CITY PLANNING COMMISSION

APPLICANT	The Spink Corporation - PO Box 2511, Sacramento, CA 9581		
OWNER	H. C. Elliott, Inc. - 11093 Sun Center Drive, Rancho Cordova, CA		
PLANS BY			
FILING DATE	2-17-84	50 DAY CPC ACTION DATE	REPORT BY: GM:sg
NEGATIVE DEC.	2-27-84	EIR	119-070-04,53,55; ASSESSOR'S PCL. NO. 119-080-04

- APPLICATION:
1. Negative Declaration
 2. Rezone 65.3± vacant acres zoned Single-Family (R-1) and Townhouse (R-1A) to Single Family (R-1) exclusively
 3. Tentative Map to resubdivide 65.3± vacant acres into 301 lots for single family residential development
 4. Subdivision Modification to create lots in excess of 160' in depth

TENTATIVE SUBDIVISION MAP

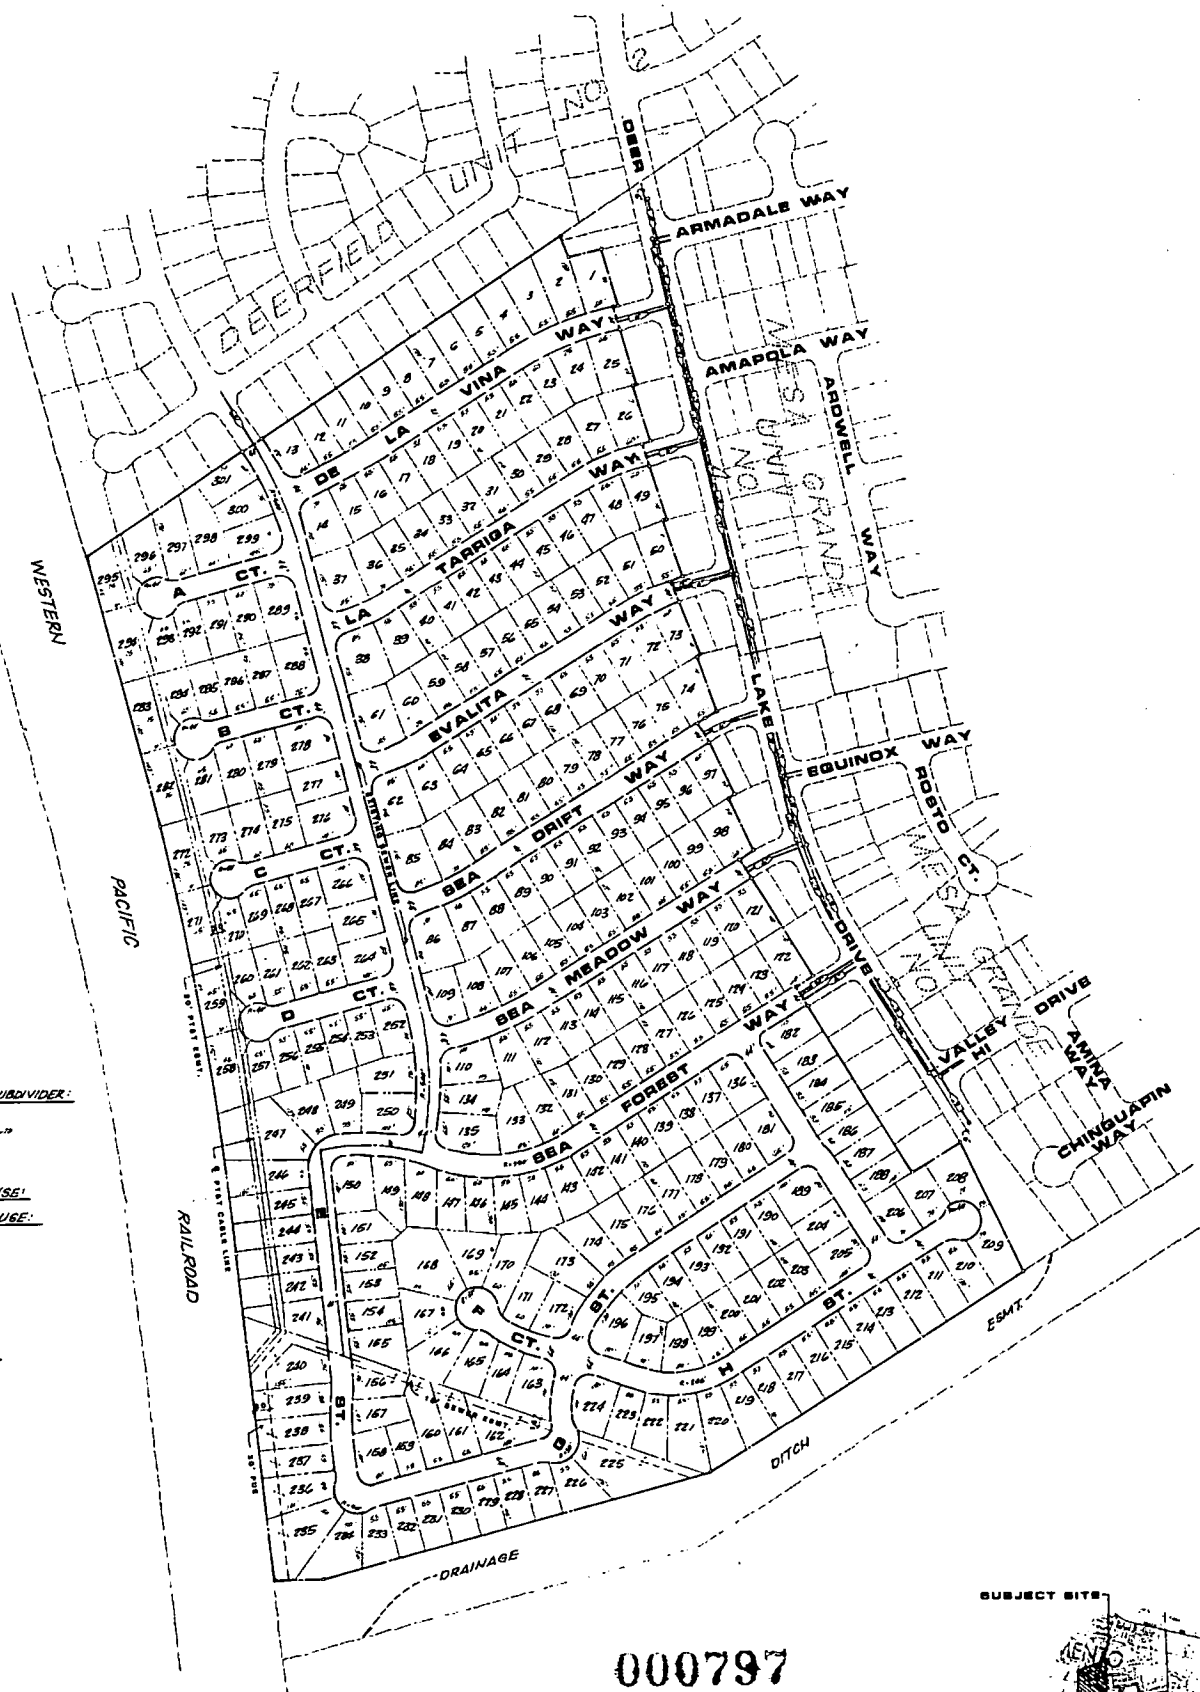
1. Provide standard subdivision improvements pursuant to Section 40.811 of the City Code;
2. Prepare a sewer and drainage study for the review and approval of the City Engineer; may require relocation of existing sewer across lot 156;

7. Provide knuckle transitions at 90° turns.

1. The Environmental Coordinator has determined tht the proximity of the proposed project to the Western Pacific Railroad tracks may expose people to severe noise levels. However, the following mitigation measure will reduce the exterior noise levels to less than a significant impact.

2. The Planning and Community Services Departments have determined that 2.77 acres are required for parkland dedication purposes based upon the revised tentative map. The subdivider shall submit to the City an appraisal of the land to be subdivided. Said appraisal shall be dated and submitted no more than 90 days prior to filing the final map with the City Council.
3. The staff has no objection to the proposed rezoning and changes to the tentative map to permit all single family uses. The proposed project is compatible with the surrounding development and the current community plan which designate the site for low density residential.
4. Lots 225 and 250 have lot depths greater than 160 feet. Staff has no objection to the subject deep lots in that the proposed lotting pattern and street configuration does not permit standard lot depths.

- A. Provide standard subdivision improvements pursuant to Section 40.811 of the City Code;
- B. Prepare a sewer and drainage study for the review and approval of the City Engineer; may require relocation of existing sewer across lot 156;
- C. Pursuant to City Code Section 40.1302 (Parkland Dedication), the applicant shall submit to the City an appraisal of the property to be subdivided and pay the required parkland dedication in-lieu fees. The appraisal shall be dated not more than 90 days prior to the filing of the final map;
- D. Pursuant to City Code Section 40.319-1, the applicant shall indicate easements on the final map to allow for the placement of centralized mail delivery units. The specific locations for such easements shall be subject to review and approval of the City Engineer after consultation with the U.S. Postal Service;

- E. The applicant/developer shall designate and place on the final map those structures and/or lots which will meet the required eighty percent (80%) south orientation (including solar access) to the satisfaction of the Planning Director;
- F. Prepare a sound study regarding the Western Pacific Railroad tracks. The study shall be approved by the City/County Health Department and the City Planning Department. Noise mitigation measures, if required, shall be indicated on the final map. If a sound barrier is required, the applicant shall construct a wall out of solid decorative masonry wall material. The design and details of the masonry wall shall be submitted to the Planning Director for review and approval prior to recordation of the final map.
- G. Provide knuckle transitions at 90° turns.
